REMARKS

Objection to the Drawings

IN THE DRAWINGS

Fig. 3

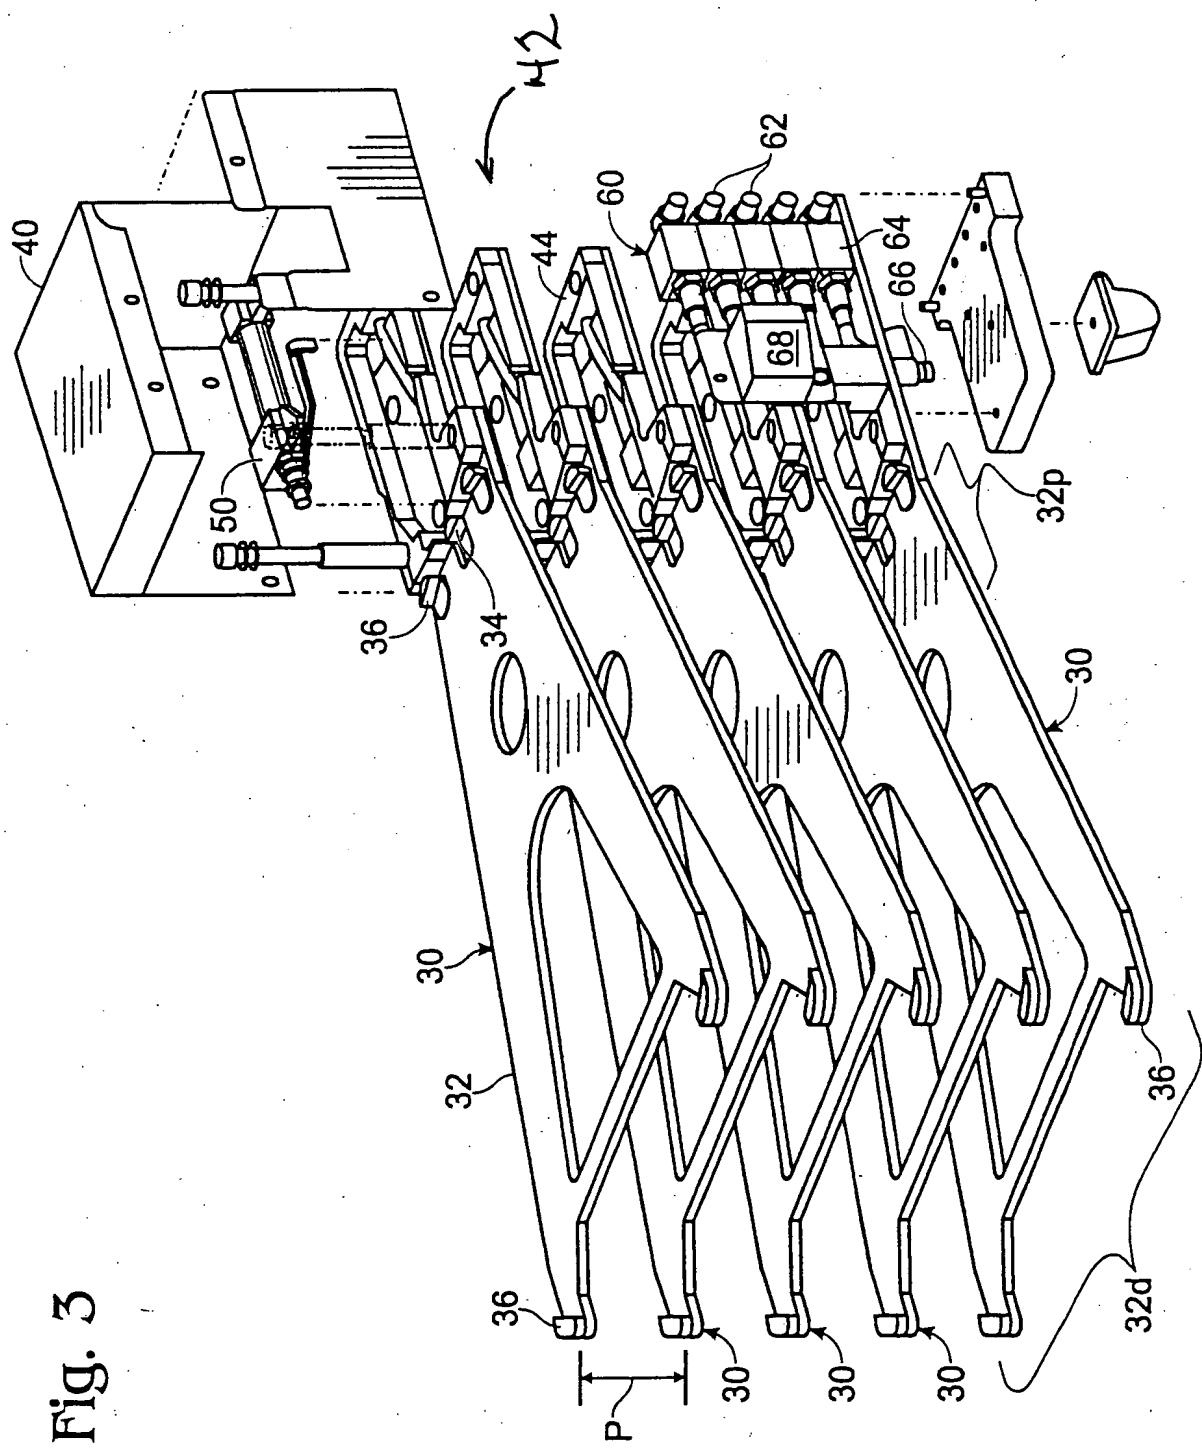
The drawings have been objected to as failing to illustrate “sub-bodies” (as disclosed in the specification at, for example, page 4, lines 1-8).

The drawings have been objected to under 37 C.F.R. § 1.83(a). FIG. 3 has been corrected in compliance with 37 C.F.R. § 1.121(d). Applicant submits herewith Annotated Sheet Showing Changes and Replacement Sheet.

Applicant tenders a Replacement Drawing Sheet for FIG. 3, which labels a sub-body as “42”. This structure is disclosed in the specification and no structure has been added to the figure. No new matter has been added by the addition of this reference numeral.
